Product Change Notice (PCN)

PCN Number: **PCN-0451210R-01**

Product(s) Affected: *PJ-059A*

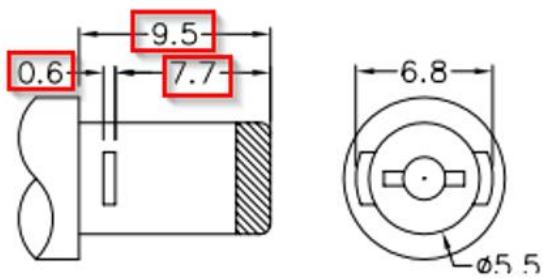
Description of Change: *Minor Housing and footprint differences. Material Change on the housing and terminals. See image Below*

PREVIOUS CUI DEVICES DETAIL / IMAGE			NEW CUI DEVICES DETAIL / IMAGE		
	MATERIAL	PLATING	DESCRIPTION	MATERIAL	PLATING/COLOR
center pin	copper	nickel	center pin	brass	nickel
terminal 1	brass	tin	terminal 1	brass t=0.30	tin
terminal 2	copper alloy	tin	terminal 2	bronze t=0.25	tin
terminal 3	brass	tin	terminal 3	brass t=0.30	tin
plastic	PBT		cover	PBT (UL94V-0)	black
			housing	PBT (UL94V-0)	black

MATING PLUG
Jack Insertion Depth: 9.8 mm

MATING PLUG
Jack Insertion Depth: 9.5 mm
